**PLANNING COMMITTEE REPORT**  
**ADDENDUM**

PLANNING COMMITTEE		AGENDA ITEM
Date:	7 June 2022	NON-EXEMPT

Application number	P2021/2270/FUL
Application type	Full Application
Ward	Caledonian
Listed building	34B York Way - Grade II Adj. 5-35 Balfe Street - Grade II
Conservation area	Kings Cross Conservation Area (CA21) Adj. Keystone Crescent Conservation Area (CA14) Adj Kings Cross Conservation Area (LB Camden)
Development Plan Context	Core Strategy Key Area – Kings Cross and Pentonville Road Central Activities Zone Employment Growth Areas (Kings Cross) Protected vistas - Parliament Hill summit to St Pauls Cathedral Protected vistas - Kenwood viewing gazebo to St Pauls Cathedral Article 4 Direction A1-A2 (Borough wide) Article 4 Direction B1(c) to C3 (CAZ) Article 4 Direction Flexible uses Article 4 Direction Office to residential
Licensing Implications	None
Site Address	34 York Way (Jahn Court), 34B York Way (The Hub), Albion Yard and Ironworks Yard, Regent Quarter, Kings Cross, London N1
Proposal	Refurbishment of existing building; 5 storey partial infill extension to eastern elevation, single storey extension to northern elevation and two storey roof extension with roof terrace

***Image 1 – Proposed and Revised changes to massing***

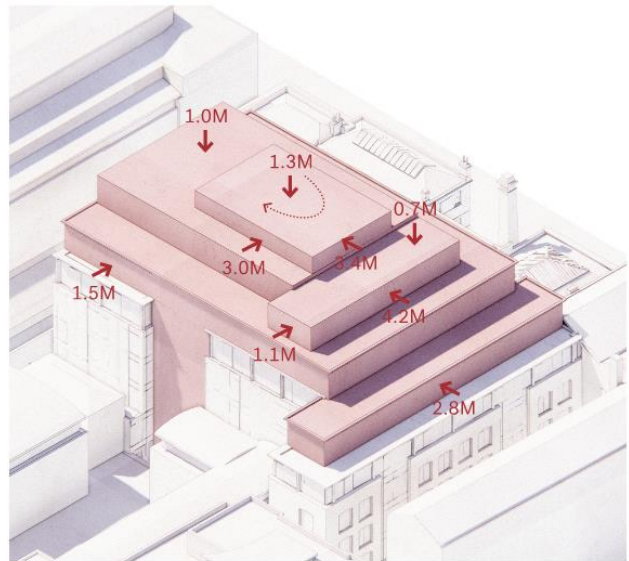
- The overall height of the proposed development has been reduced by 1.3 metres.
- The massing of the proposed roof extensions has been reduced at various levels as follows:

- Fourth floor extension recessed by 2.8 metres from the northern elevation;
  - Fifth floor east infill extension recessed by 1.5 metres from the eastern elevation;

- Fifth floor gallery and plant level recessed by 3.7 metres from the north and recessed by 1.1m to the east; and
  - Upper roof plant level recessed by 3.4 metres to the north and recessed by 3 metres to the east, as well as reduced in height by 1.3 metres.

- 3.12 Image 1 shows a comparison between the height and massing of the proposed roof extensions on the previous scheme and those now proposed as part of the revised scheme. The image includes the dimensions of the reductions that have been made in height and massing.

**Image 4 – Proposed and Revised North South Section**

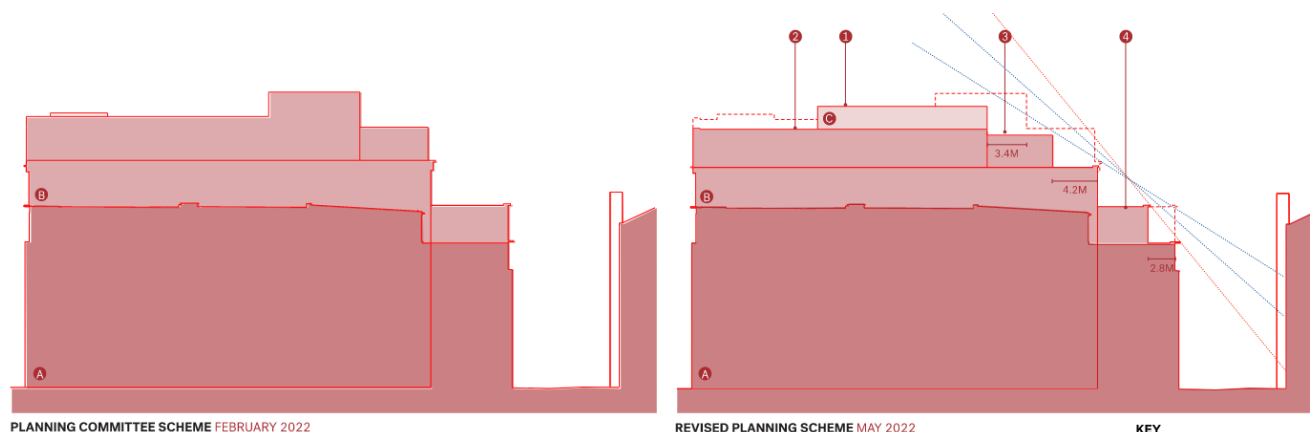
- 3.20 The reduction in mass to the fourth storey has led to betterments, in the reductions to daylight and sunlight to neighbouring properties.

- 3.21 In image 4, part A indicates existing massing, and part B indicates the proposed additional massing, and part C indicates the proposed massing recessed.

**Image 5 – Revised proposed ground floor plan – Provision of Affordable Workspace**

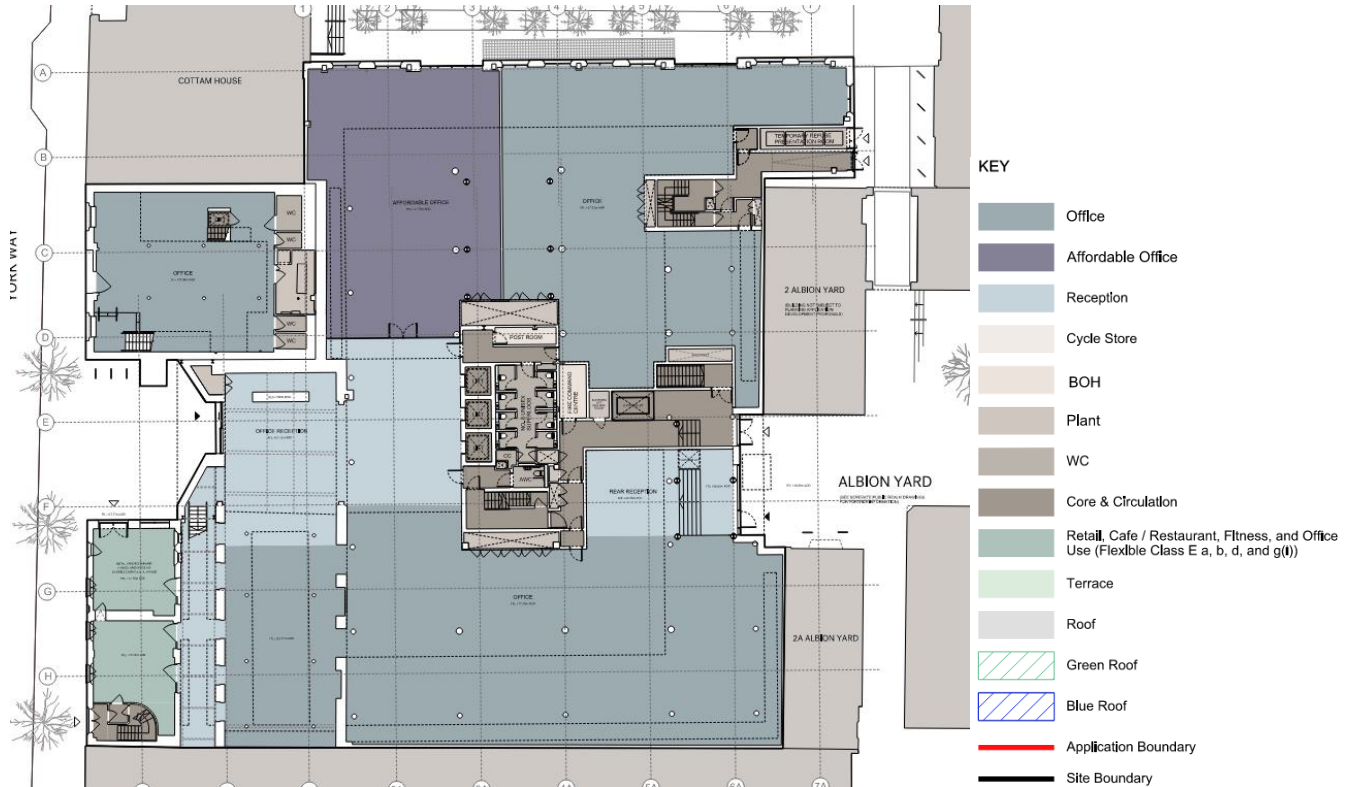
- 3.41 For the current application, the affordable workspace is proposed to be located on the ground floor of the Jahn Court building. The area of this allocated space will be 241sqm and this represents 10.7% of the uplift in office floorspace proposed by the application. This is shown below (Image 5) on the revised ground floor plan.

- 3.42 The space will be open plan and is proposed to be fitted out to a Category A standard. The location on the ground floor of the main building enables access to the basement cycle storage and ground floor WC's. The lease length of the proposed affordable workspace offer has been increased from 10 years to 20 years on a peppercorn rent.

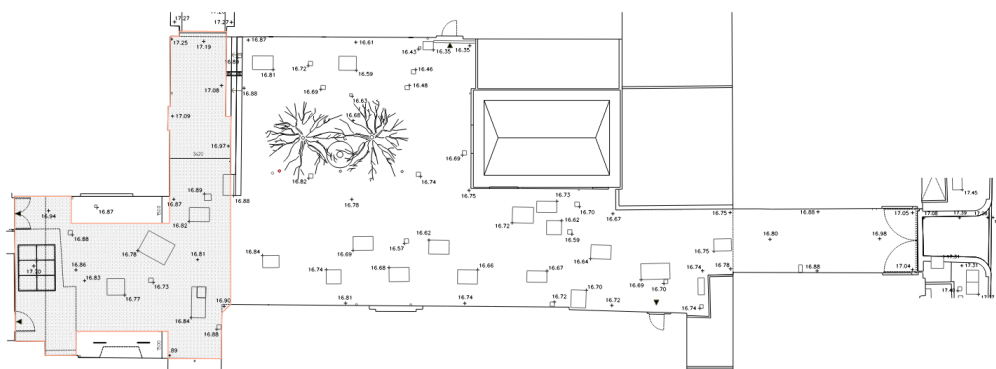
- 3.48 It is proposed to reduce the extent of proposed works to flatten the setts of cobbles which cover the east-west route within Albion Yard. This change has been made to the scheme to respond to resident's concerns that the new pathway will adversely impact on their amenity by the external area becoming more used and busy in close proximity to their properties.
- 3.49 The application scheme will continue to provide treated sanded setts along the north-south route of Albion Yard to facilitate improvements to accessible access, as shown in Image 7 below.
